Circuit Change

PROBLEM: *When using the component out on the L70 you may find the video signal has faint diagonal lines appearing.*

Photo 1

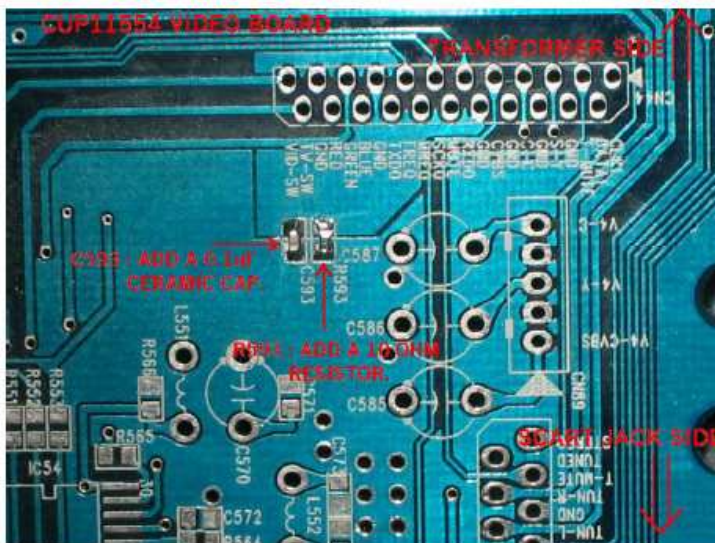
CAUSE: *The ground plane requires additional coupling.*

SOLUTION: *Add a 10 ohm resistor to location R593 on the video board. Add a 0.1uF ceramic capacitor to location C593 on the video board. See photo below.*
